Boundary Creek, Big Swamp and Surrounding Environment – Remediation and Environmental Protection Plan

Scope of Works

Independent Expert Review of the Acid Sulfate Soil Preferred Management Options for Yeodene Swamp

Expert Panel for the Boundary Creek remediation plan: Review of the preferred concept design

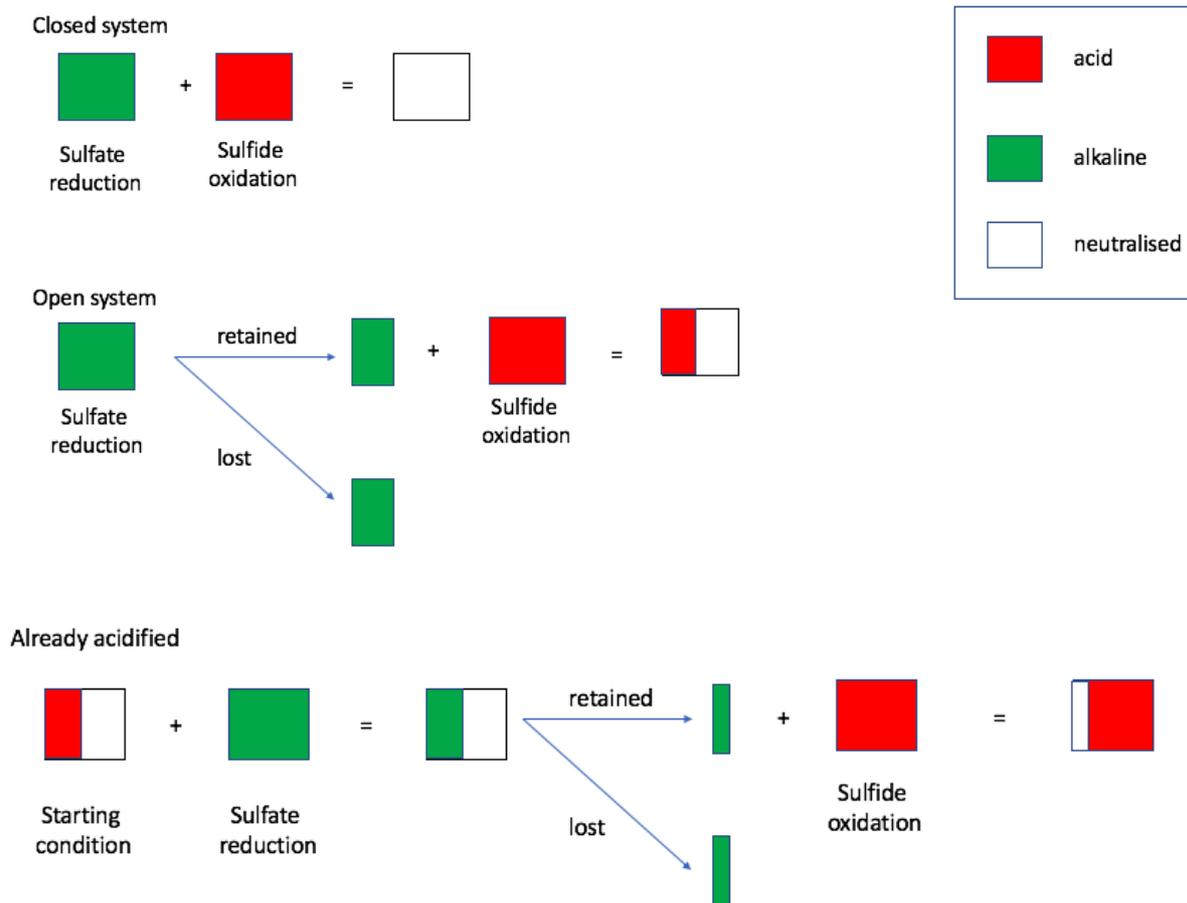
Because Yeodene is an open system that does not retain all of the alkalinity produced during ASS formation, the approach of inundating Yeodene Swamp, and only relying on alkalinity created during new ASS formation to neutralise acidity produced in previous ASS formation events, is flawed. It creates a pool of ASS in the swamp that doesn't have any associated neutralising capacity associated with it, because this neutralising capacity has already been used up to neutralise previous acidity - a bit like robbing Peter to pay Paul (Figure 1). When the swamp dries out again, there will be another acidification event.

It is highly likely Yeodene Swamp will dry out in the future, notwithstanding the introduction of the proposed barrier and new flow rules downstream of McDonald's Dam. The drying of Yeodene Swamp will most likely be caused by three factors - a drying climate, lowering of the water table through groundwater extraction, and the operation of McDonald's Dam - all often acting at the same time during extended periods of drought.
